White Hill Wind Farm

Annex 13.1: Stage I Road Safety Audit

White Hill Wind Farm, Co.
Carlow

Stage 1 Road Safety Audit

Figure 2.3 – Eastern Access Junction Visibility Splay

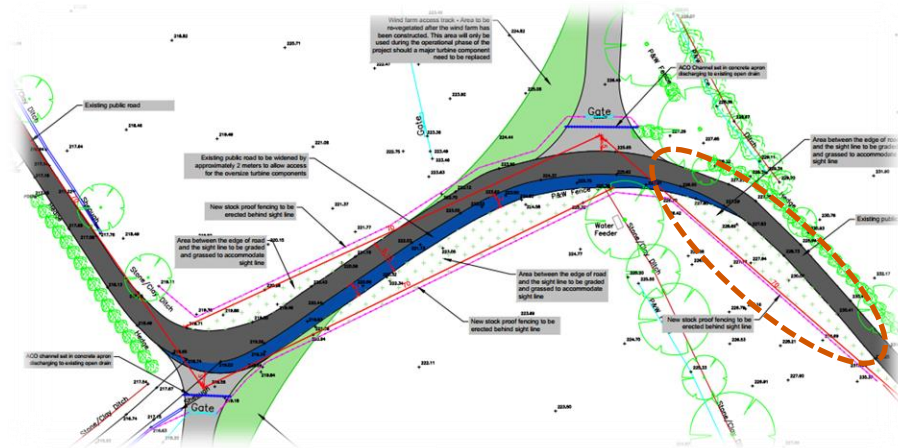
2.3 Problem: Existing Ground Profile Along Visibility Splay

Location: Eastern Access Junction onto Local Road

The existing ground profile to the east of the access junction may result in an obstruction of the visibility splay leading to visibility issues for vehicles exiting the access junction.

The ground profile should be graded to ensure the access junction visibility splay is not obstructed.

2.2	Yes	Yes	The identified trees and overhanging branches will be removed as part of the carriageway widening works.	
2.3	Yes	Yes	All ground levels will be graded such that they do not interfere with the provision of visibility splays.

Figure 2.4 – Access Track

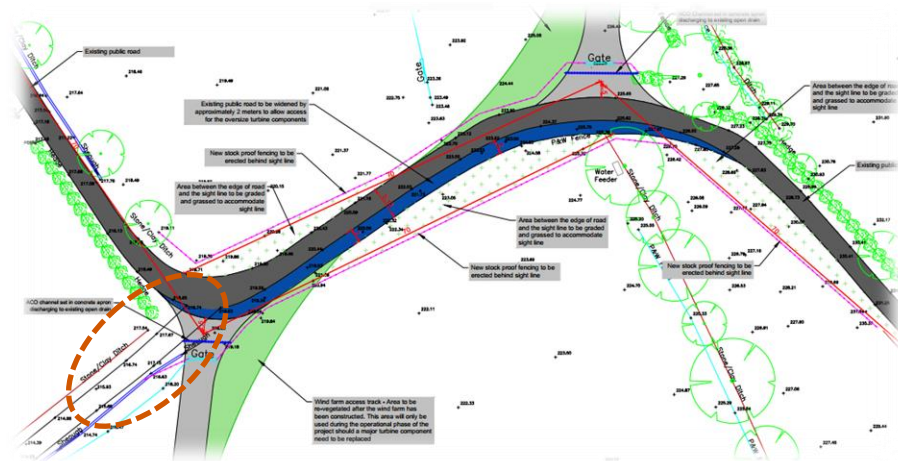
2.4 Problem: Access Track Connection

Location: Access Track onto Local Road

Failing to provide an appropriate interface between the access track and the western access junction could lead to driver confusion and conflict.

Provide an appropriate interface between the access track and the western access junction.

2.4	Yes	Yes	The interface of the junction with the private access track (extremely limited day-to-day usage) will be re-designed to avoid any conflict.
